Multichannel Network Interface Controller for HDLC
MUNICH32

PEB 20320 Version 3.4
PEF 20320 Version 3.4

Delta Sheet for the Version 3.4

This document describes the latest MUNICH32 (Version 3.4) in relation to the Version 3.2 and hence is a "Delta Sheet" which references the MUNICH32 User's Manual 01.96 (V 3.2).

1.2 Pin Configuration
(top view)

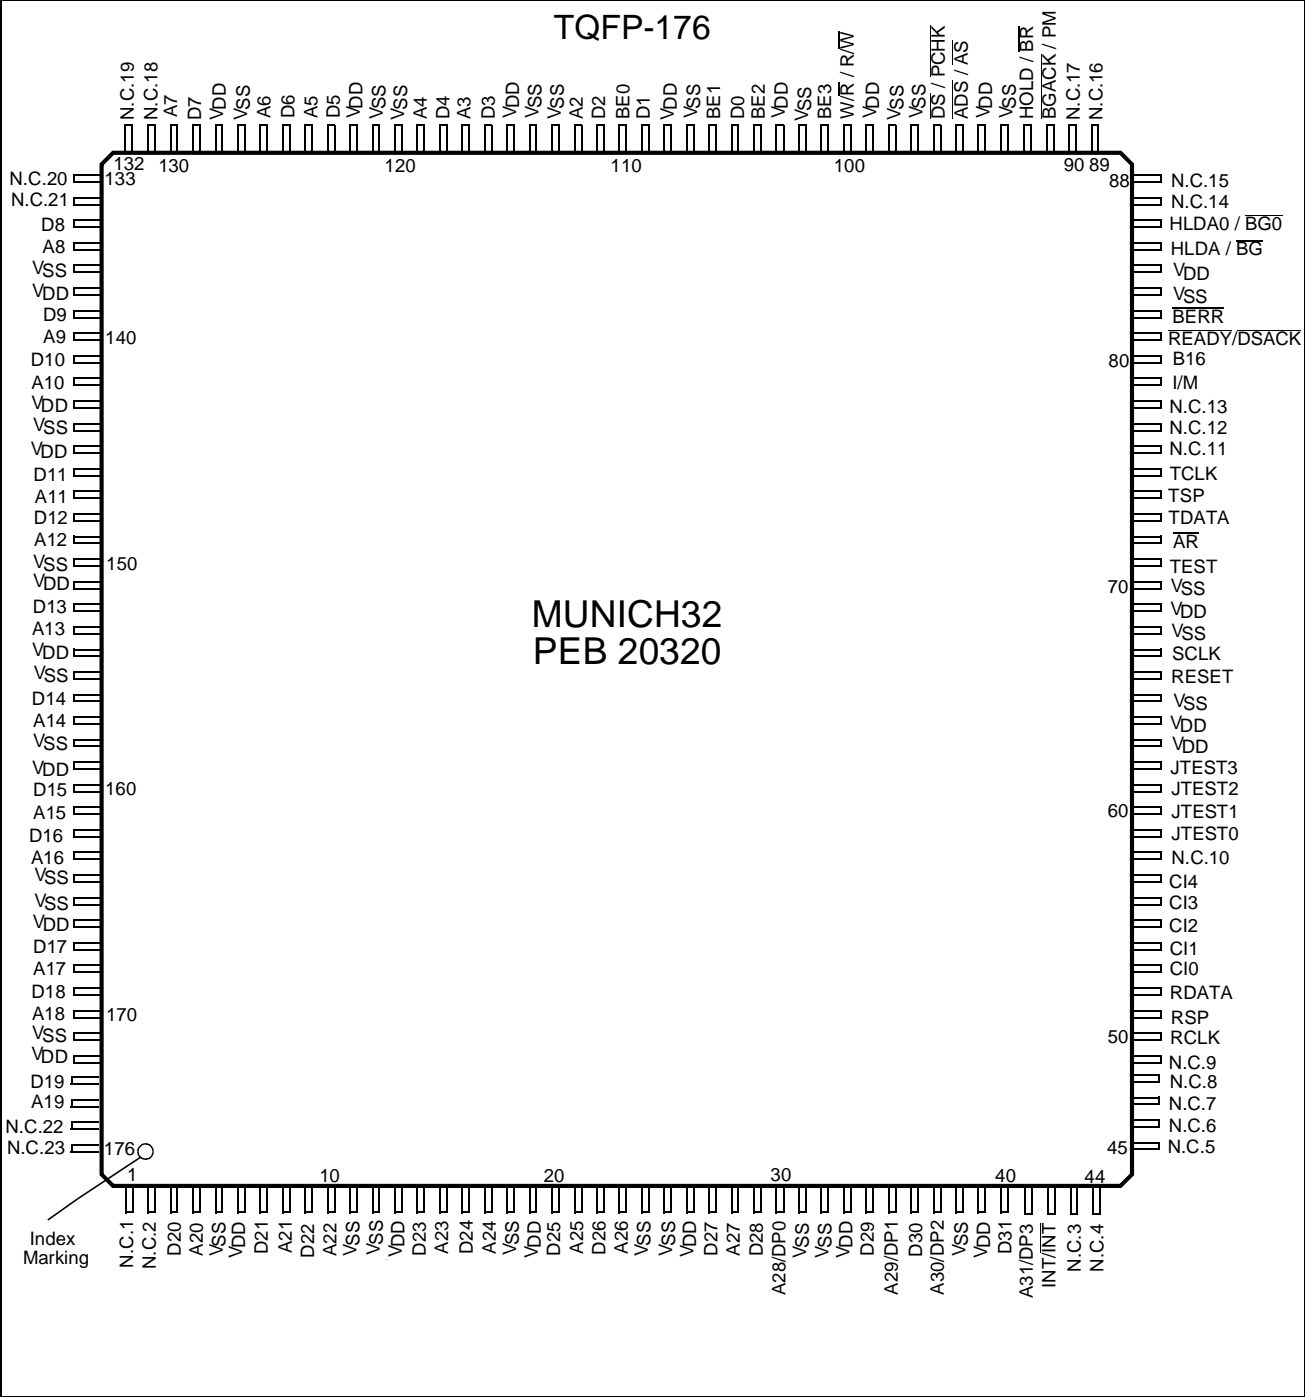
MUNICH32 V3.4 is provided in both packages: P-MQFP-160-1 and P-TQFP-176.
